Access Compliance Report Public Rights-of-Way (Curb Ramps)

Main Street: HARPER_ST Cross Street: WASHINGTON_AVE Location: NE

ADA ID: RPRK211001112228 Ramp Type: Type 1 - Perpendicular Diagonal Initial Pass/Fail: Pass Overall Compliance: No Severity Score: 0

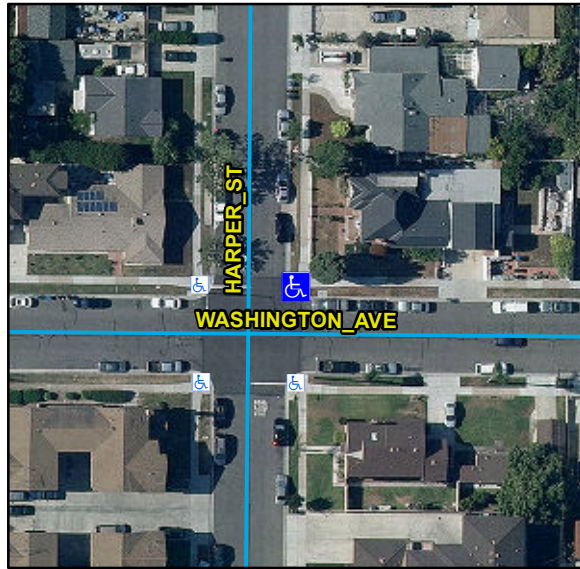
R304.2.1, R304.5.3, STD 1115

Remove & Replace Landing. Remove & Replace Gutter.
